City of Surrey PLANNING & DEVELOPMENT REPORT Application No.: 7919-0177-00

Planning Report Date: May 15, 2023

To permit the development of three, 6-storey apartment buildings, containing 319 dwelling units, over a shared two-level underground parkade, in City Centre.

## RESPONSE SUBMISSION TO ADP COMMENTS

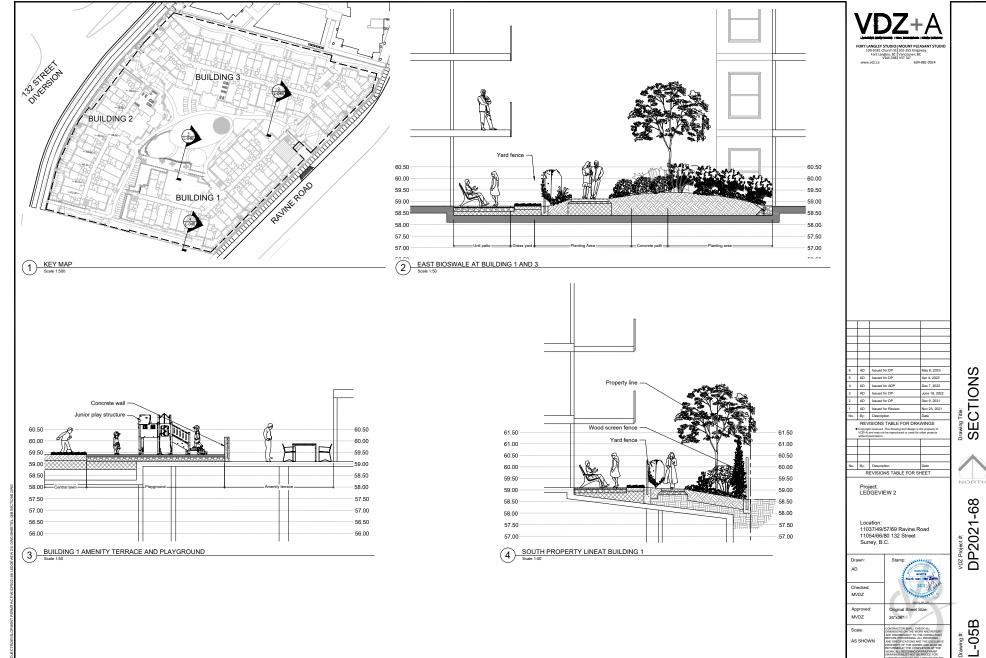
- Sheet Lo<sub>4</sub>D section 2 shows narrow strip of sod on a slope with a planting area that appears to be less than 300mm width. Recommend increasing planting bed and soil depth to allow for adequate separation and privacy of private patios at playground. This section is cut through the accessible

- pedestrian access point for the playground and shows the adjacent walk. The planting strip has the required soil depth for shrub planting and any enlargement to the planting area would eliminate the yard for this unit. This condition only applies to this single yard.
